1963 - 1965 Corvette: Service Bulletin: Drive Line Noise

Source: Chevrolet Technical Service Bulletin

Bulletin No: #1069

Date: January 7, 1965

FIGURE 1

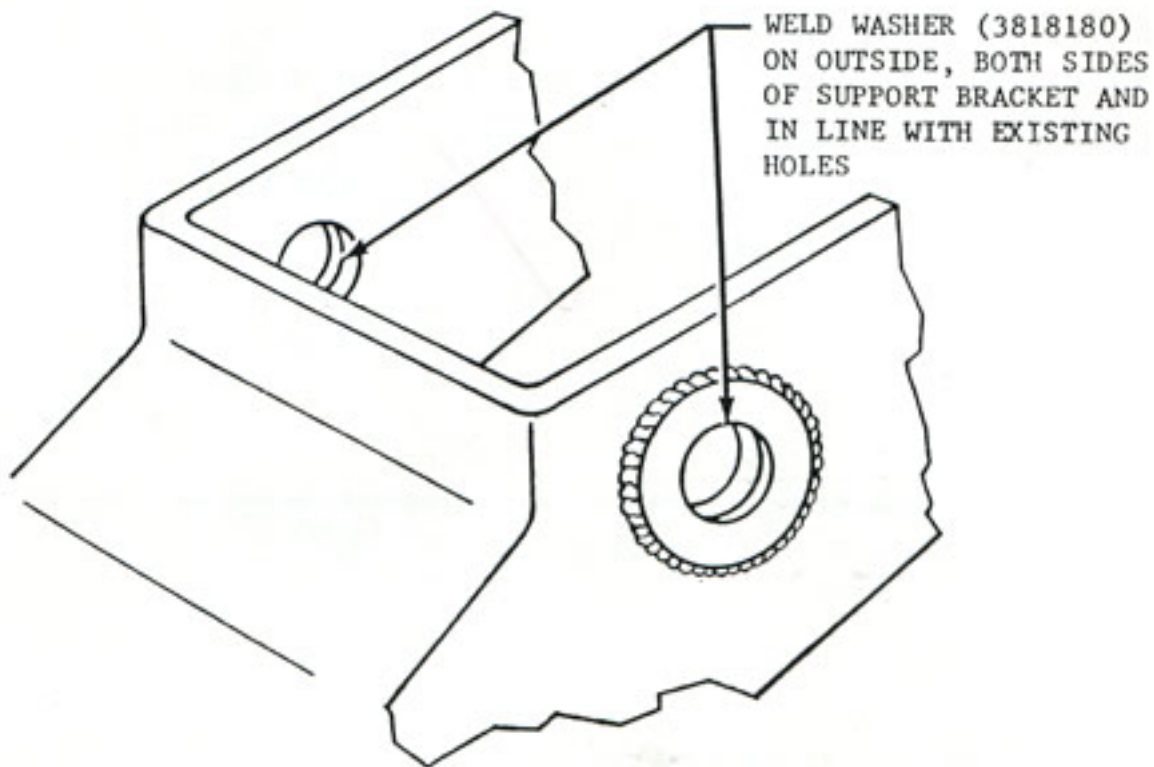
A clunking noise may occur in the drive line of some 1963-65 Corvette on initial vehicle movement in either forward or reverse gear. This could be caused by loosening of the differential carrier support bracket front attaching bolts. Loosening of these bolts will also result in elongation of the bracket bolt holes.

If elongation of bracket bolt holes occur, the differential carrier bracket should be replaced with bracket Part No. 3868799. However, the original service bracket Part No. 3820186, can be used by reinforcing it as shown in Part I of this bulletin. In conjunction with the installation of the bracket, it will be necessary to secure the forward attaching bolts as outlined in Part II of this Bulletin.

1. If reinforced bracket, Part No. 3868799 is not available, obtain Part No 3820186 and weld one flat washer, (Part No. 3818180) on each outside surface in line with existing holes (See Figure 1.)

FIGURE 2

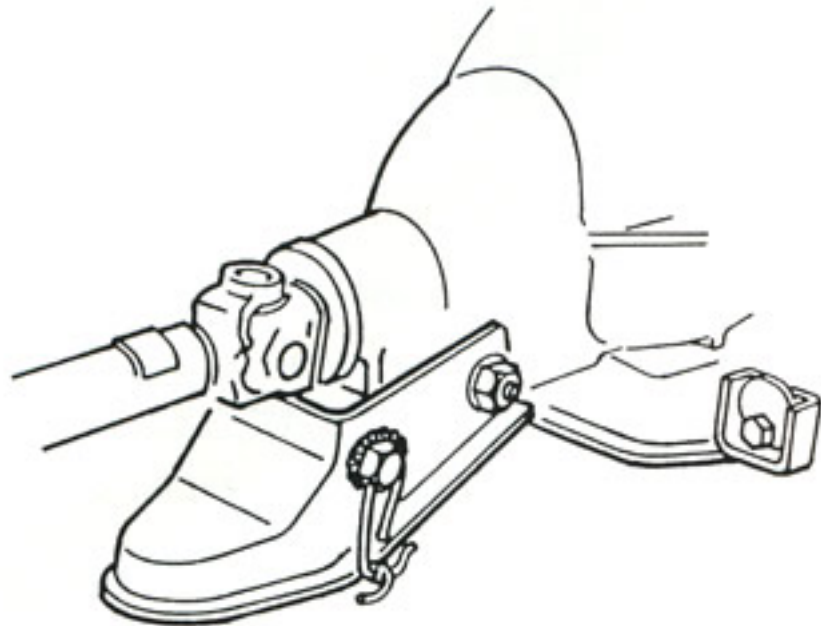
1. Obtain (2) 7/16-14 x 1 300M bolts and drill a 3/32 inch diameter hole through the head of each.
2. Drill a 3/32 inch diameter hole through the lower flange of the carrier bracket directly below the forward bolt hole (both sides of bracket).

3. Install new bracket using modified forward attaching bolts. Torque forward attaching bolts to 65 ft. lbs.
4. Safety wire the forward bracket bolts to the bracket with stainless steel safety wire (1/16 inch O.D.) or stainless steel welding rod (1/16 inch O.D.).

NOTE: Be sure the straight wire form the bolt head to the flange hole is on the tightening side of the bolt. (See Figure 2).

5. Tighten the wire sufficiently by twisting the ends together. NOTE: Over-tightening will cut the wire at sharp bends.
